service bulletin

No. 93-4

A. REQUIRED FLAME ARRESTOR REPLACEMENT

MCM 5.7L Alpha Stern Drive Engines Only
Serial Number: 0F000455-0F010698

71798

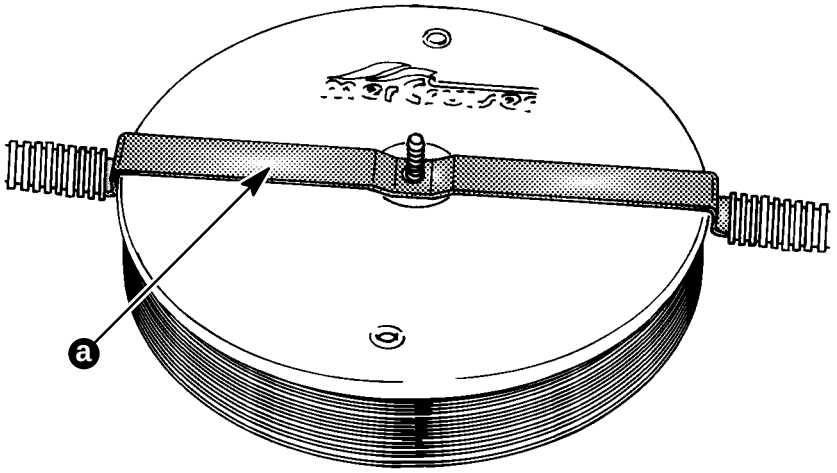
This engine had the wrong model flame arrestor installed. This will cause the engine to run rich.

Remove cover and look at the flame arrestor.
Without vent hose cross piece - wrong type, must be changed.
With vent hose cross piece – correct type, do not change.

(1) 805298A1 Flame Arrestor
